Dynamic displacement measurement of a wind turbine tower using accelerometers: tilt error compensation and validation

Answers to the reviewer's comments

Figure 1: Double logarithmic representation of the frequency-depended correction factor of a_{meas} as a function of frequency for $gm = 0.4267 \; \frac{1}{s^2}$. There is no phase change due to the tilt error compensation.

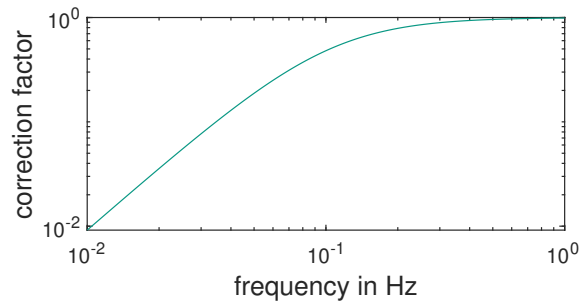
- **Figure 3: axis description missing**

We have labelled the axes and changed the caption as follows (page 8):
